# SES SOLAR ONE

## Supplemental Information In Response to CEC Data Adequacy Requests Application for Certification (08-AFC-13)

April 2009

**SES Solar One**  
**Supplemental Information**  
**In Response to CEC Data Adequacy Requests**  
**08-AFC-13**

Figure 5.7-1	Topographic APE Map
--------------	---------------------

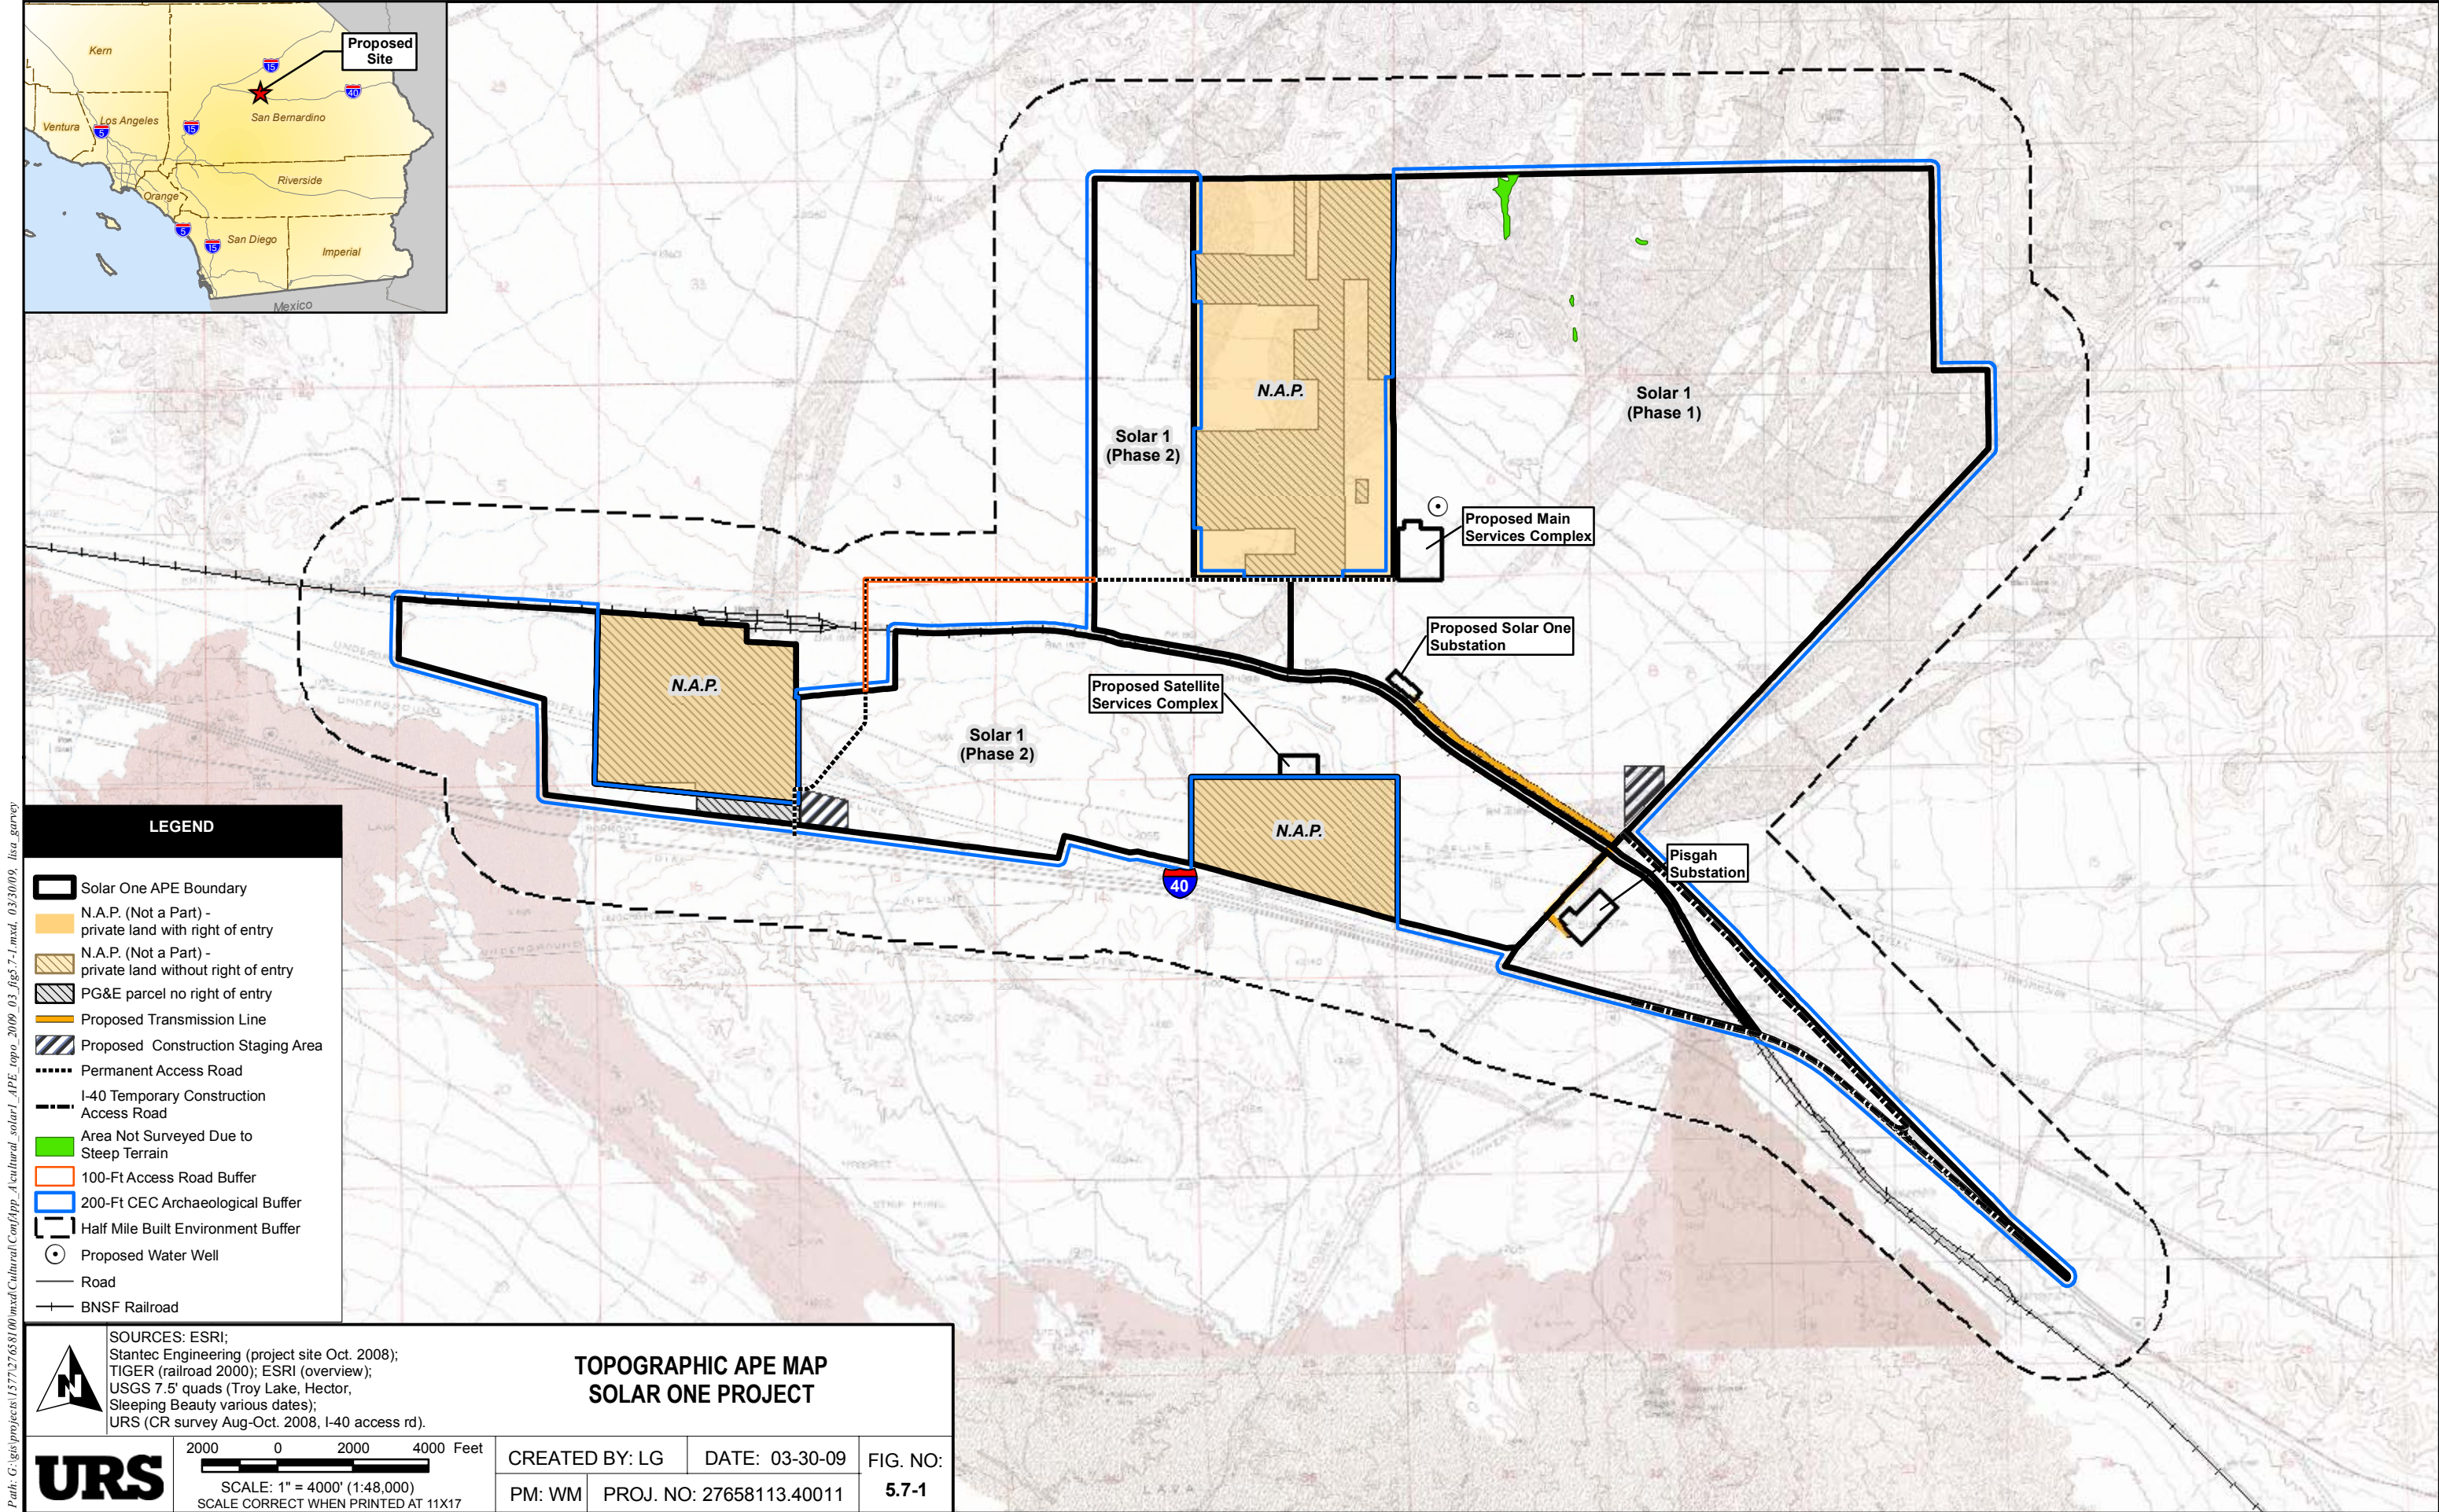
**Response:** This information has been globally changed throughout the revised Section 5.7 of the AFC provided as Attachment CUL-1 and in the technical report (provided under separate cover). Figure 5.7-1 in attachment depicts the survey coverage, as described below.

The Project APE referenced refers to 100 percent of the Project site, linear facility routes, and ancillary project areas, which are contained within the APE, as well as the appropriate regulatory buffers (Figure 5.7-1).

Areas of steep terrain (greater than 45°angle) where access was not feasible due to unsafe/unstable surfaces were not surveyed. These areas total less than 11 acres and occur within the northeastern Project APE along the south-southwest facing slope of the Cady Mountains (See Attached Figure 5.7-1). The areas of steep terrain not surveyed have an extremely low

There are three Not a Part (NAP) areas within the Project APE, which include areas found in T 8N/R 5E Sections 1, 9, 13, and T 9N/R 5E Section 36 (7.5' USGS Hector quadrangle 1993 Revised, 1982 Provisional). The Project Proponent (SES) does not have a Plan of Development (POD) for the NAP areas. SES requested right-of-entry (ROE) from the private landowners to survey their parcels. The survey data is provided for the purpose of reporting on cultural resources (where authorized) within the regulatory buffers that extend into this area (Figure 5.7-1). The private parcels in which landowners refused ROE have no regulatory buffer because survey of these areas was not authorized.
